Work Order ID 75129

Item Name: Crosstube Turning Detail

DART AEROSPACE LTD	Work Order: 75129
Description: Crosstube Assembly (205/212/412 Low Fwd)	Part Number: D212-664-147
Inspection Dwg: D212-664-147 Rev: B	Page 1 of 1

DRAWING NO. D212-664-147	TITLE CROSSTUBE ASS'Y (205 LOW FWD)	REV. B	DART AEROSPACE LTD ENGINEERING ORDER		D.E.O. NO. D212-664-147-B-1	SHEET NO. SHEET 1 OF 1	SCALE NTS
DRAWN <i>qp</i>	CHECKED <i>ASS</i>	MFG. APPR. <i>AB</i>	APPROVED <i>MP</i>		DE APPR. <i>MP</i>		
DATE 11.07.15	DATE <i>11.07.20</i>	DATE <i>11.07.21</i>	DATE <i>11/07/21</i>		DATE <i>11.07.21</i>

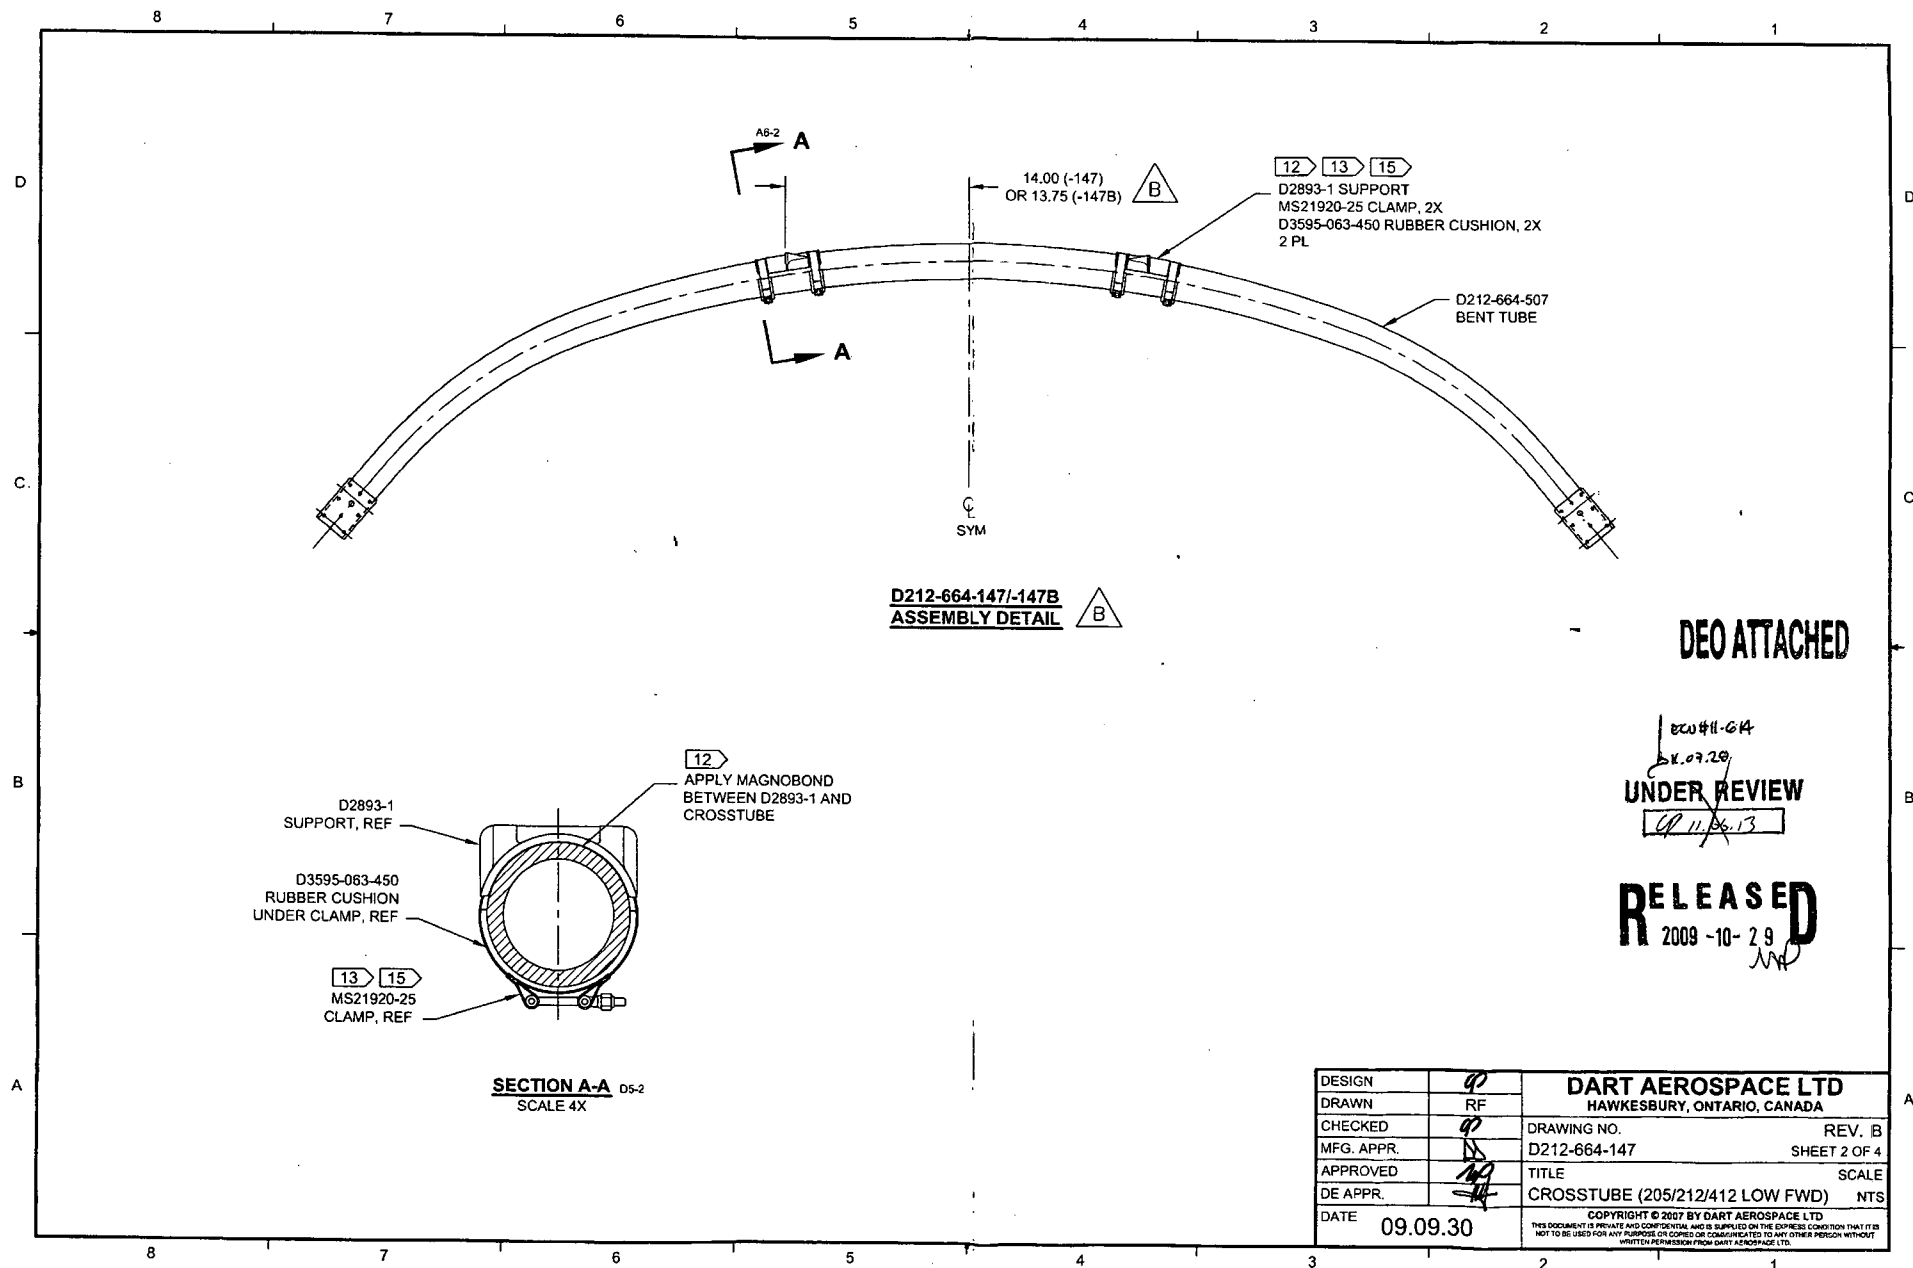
PURPOSE:

REPLACE MAGNOBOND WITH PROSEAL.

NOTE 12 & 15, SHEET 1 IS AMENDED AS FOLLOWS:

- 12) TO INSTALL D2893-1 SUPPORT: ABRASE MATING SURFACE OF SUPPORT AND CROSSTUBE WITH 180-GRIT SANDPAPER AND REMOVE RESIDUE WITH MEK (OR EQUIVALENT). APPLY A 0.04" TO 0.07" THICK LAYER OF PROSEAL 890 CLASS B-2 (OR AMS-S-8802 CLASS B-2) SEALANT TO MATING SURFACE OF SUPPORT.
- 15) TORQUE CLAMPS 80 TO 100 IN-LB. ENSURE AT LEAST 1.5 THREADS SHOWING IN SAFETY AND THAT NUT HAS NOT BOTTOMED-OUT AFTER TORQUING. **PRIOR TO PACKAGING, RE-CHECK TORQUE ON CLAMPS AFTER PROSEAL 890 SEALANT HAS CURED FOR 72 HOURS.**
